SAND CREEK RESTORATION

PUBLIC IMPROVEMENT CONSTRUCTION PLANS

EPC STORMWATER REVIEW COMMENTS ARE SHOWN IN ORANGE BOXES WITH BLACK TEXT

PCD-ENGINEERING REVIEW COMMENTS IN BLUE BOXES WITH BLUE TEXT

**GSB PROFILE 3
STA 49+00.00 TO 52+00.00**

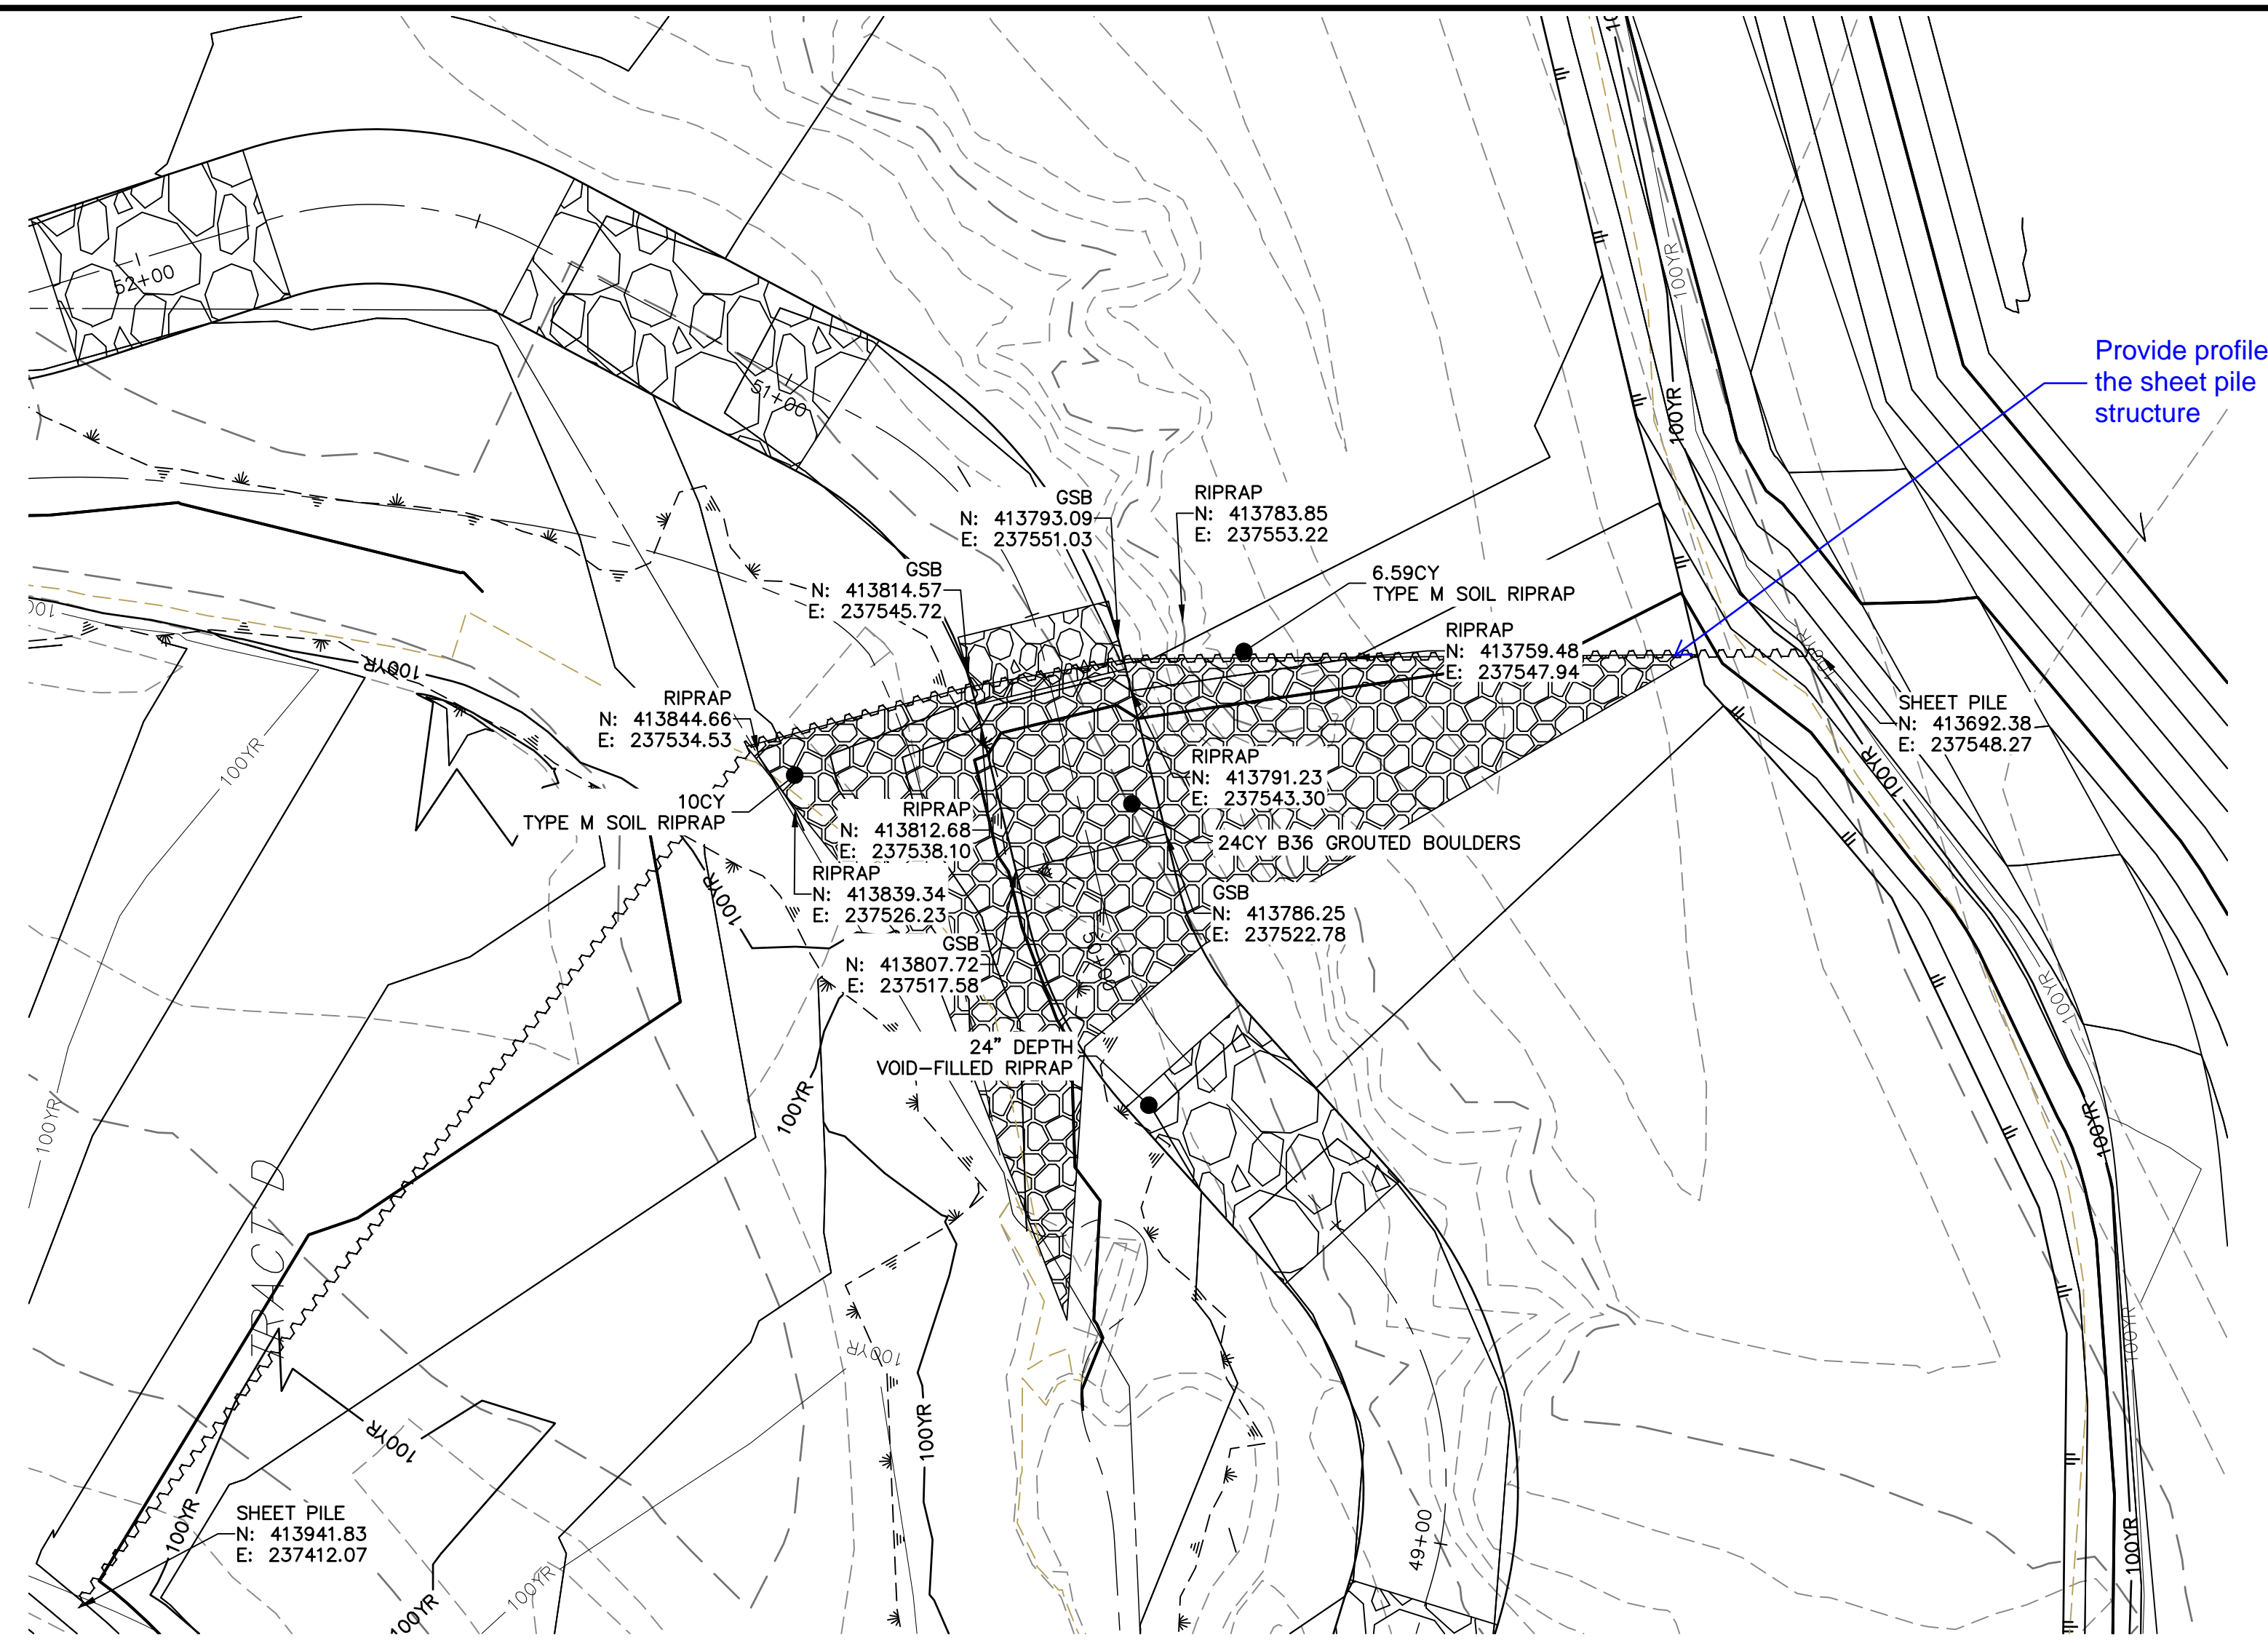
Provide profile of the sheet pile structure
